Staff Report

To: Development Review Board
From: Christopher Yuen, Community Development Director; Michael Giguere, City Planner
Meeting Date: 06/20/2024
Subject: 227-229 Pearl Street – Final Site Plan Review for proposed 39-unit multi-family dwelling in the MF-MU1 District
File: SP#2.2024.1

Fig 1: LP Smartside® LAP siding pictures with proposed colors and finish

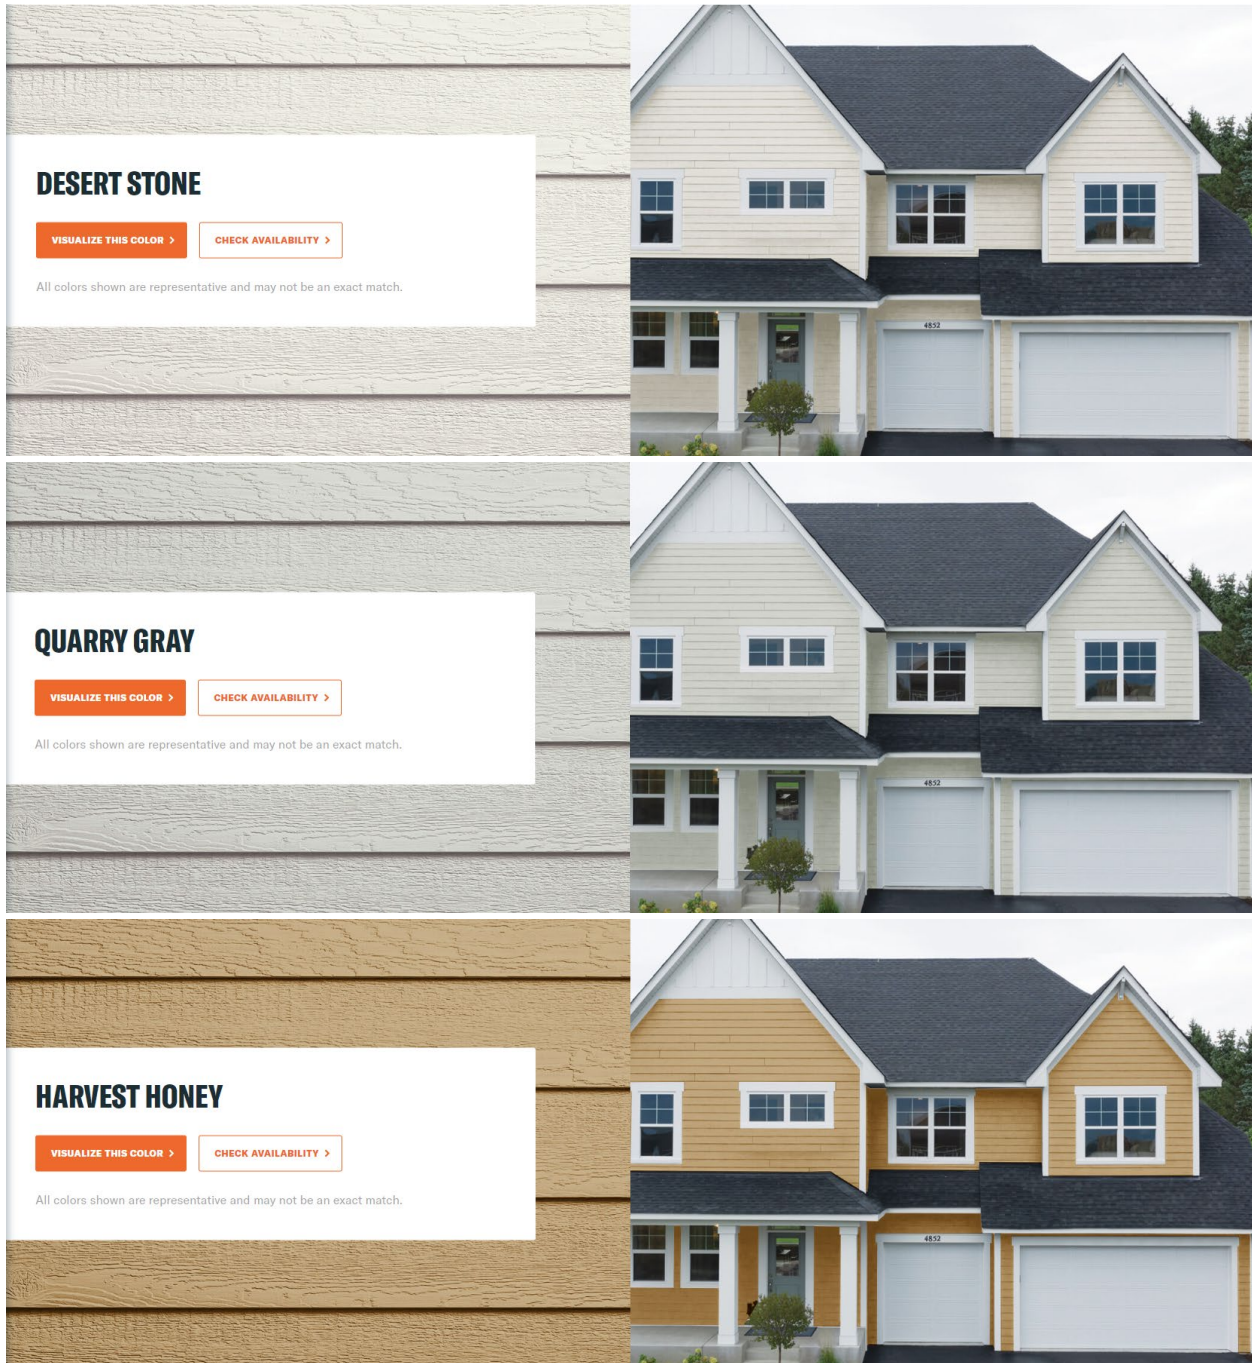
- The building’s design includes several protruding exterior sections to provide diverse textures to the building and avoid looking overly flat.
- A canopy over the front entrance is proposed.
- The building’s siding is proposed to consist of “LP Smartside® LAP siding” treated engineered wood throughout, except for one column at the front and one section at the side which are proposed to use “Board & Batten” siding.
- Proposed Colors- factory finish acrylic latex paint- LP Smartside® ExpertFinish® Desert Stone, Harvest Honey, Quarry Gray

The applicant has addressed the design review issues identified by the Development Review Board during Conceptual Site Plan review. The DRB should confirm that the current proposal meets the design review criteria in Section 620.D.
